**COMMISSION OF ARCHITECTURAL REVIEW
STAFF REPORT
April 24, Meeting**

12. **COA-033489-2018** (Obadiah LLC)

**512 West 19th Street
Springhill Old and Historic District**

Project Description: **Construct a new single family dwelling.**

1919 Sanborn Map

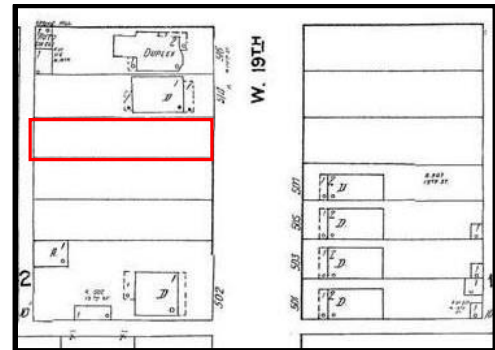
The historical pattern of the block is consistent with the setback pattern of the historic structures on the block as it appears much of the block including the subject lot was not developed. The proposed structure will have a front yard setback consistent with the historical pattern on the block.
